TMS320C6204
Digital Signal Processor
Silicon Errata

SPRZ180D
January 2002

Figure 2. Diagram showing the 0–1 and 2–3 byte–boundary from a word in data memory

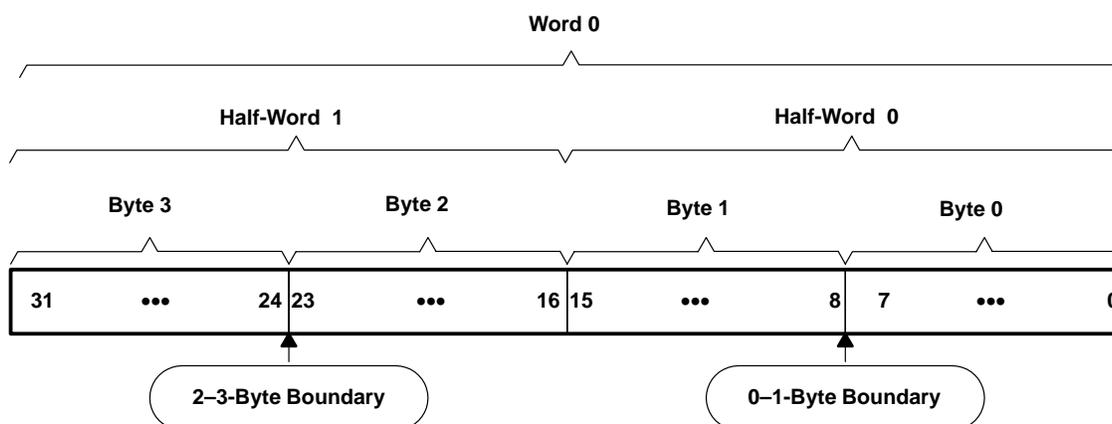
Details: Data corruption occurs when a write to data memory is followed by an instruction that modifies the byte—enables on a 0–1 or a 2–3 byte boundary, as shown in Figure 2. Essentially, an STB instruction acts as an STH instruction. Data corruption occurs at the address referenced by the first instruction. Reads from data memory, as well as both read and write accesses to program memory and external memories do not exhibit this issue.

In these examples, the second execute packet contains an instruction that modifies a byte on either a 0–1-byte-boundary (examples 1 & 2) or a 2–3-byte-boundary (example 3).

Workaround: Utilize half-word and word accesses instead of byte-wide accesses.
Avoid use of the char type from C.
